PLAN COMMISSION

A. Review of Site and Architectural Plans for the Confluence located at corner of 19th Street and East River Drive, submitted by McMahon Engineers/Architects, Kip Golden, CR Structures, and City of Two Rivers (Property Owners).

Site and Architectural Review of Confluence

Re: Confluence Lofts
DPW Plan Review / Comments

1 FIRST FLOOR PLAN

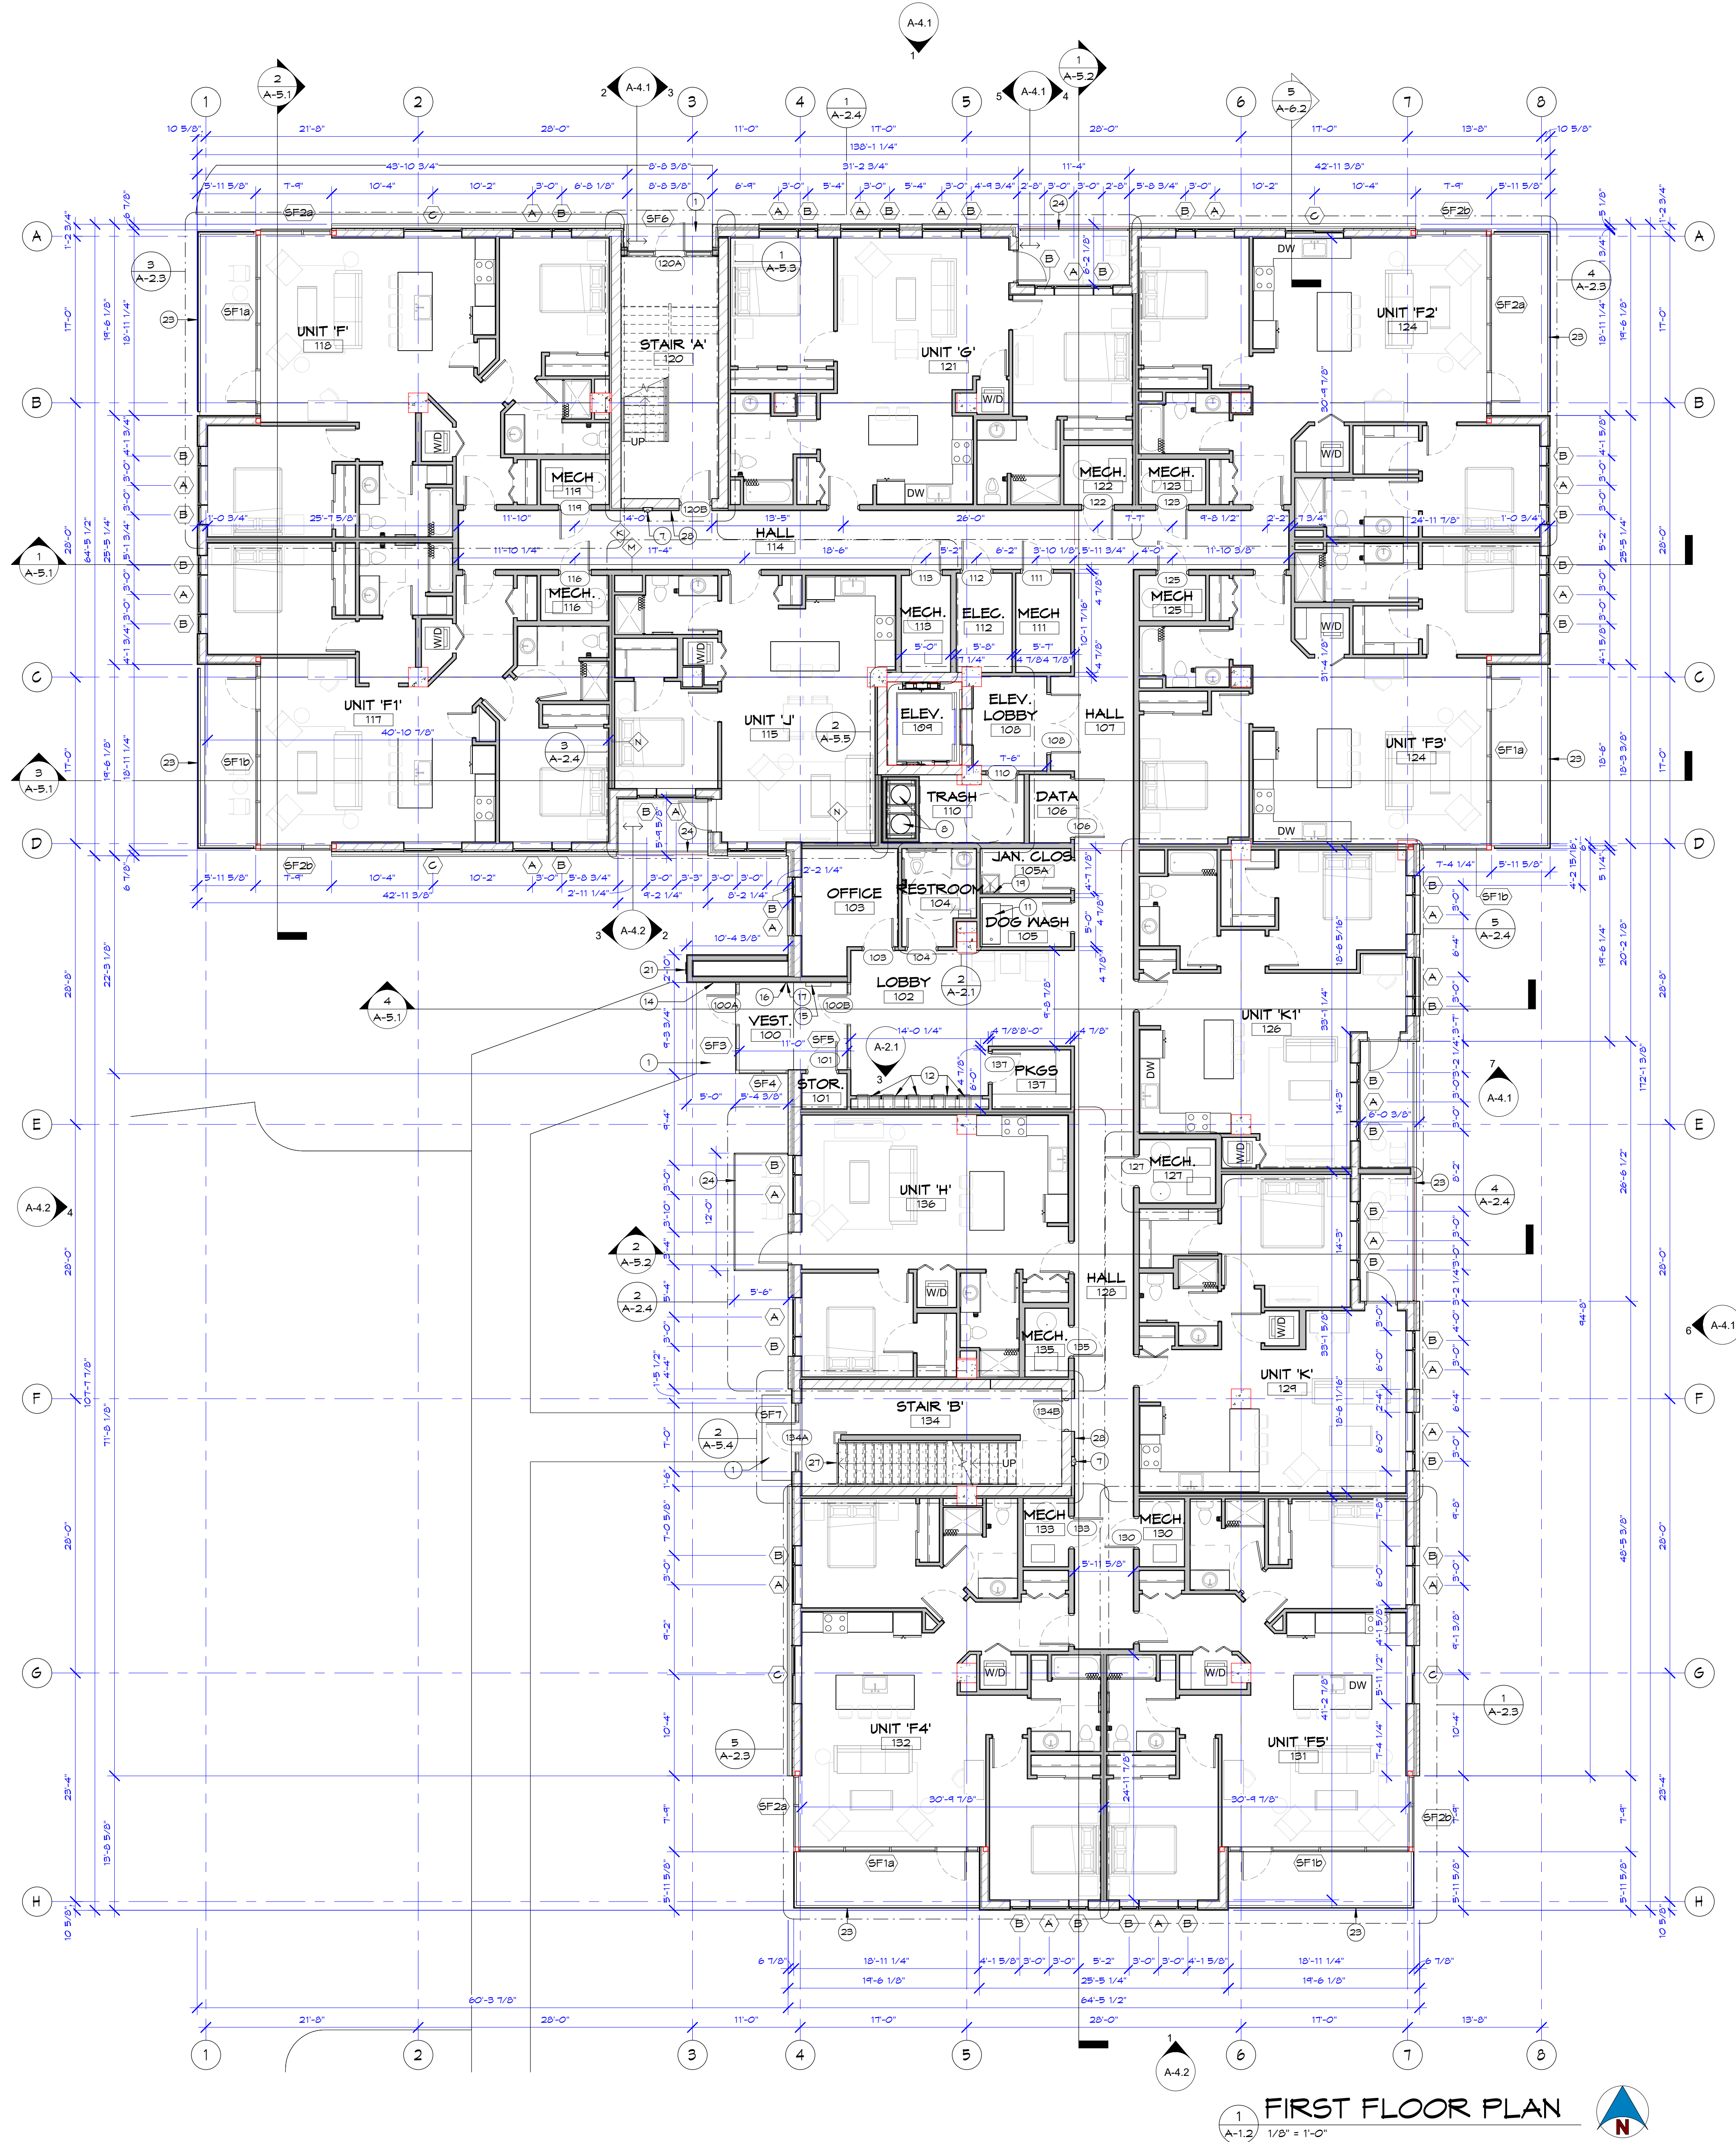
- South end of the parcel to be developed, on the west side of East River Street
- West side of 19th Street across from the development site
- North of the development on 20th Street.
- Plan Sheet A1.2 indicates Knox Box type (Fire Department Connection) will be coordinated with Fire Department
- Plan Sheet A1.3 states entire building will be sprinklered in accordance with NFPA 13
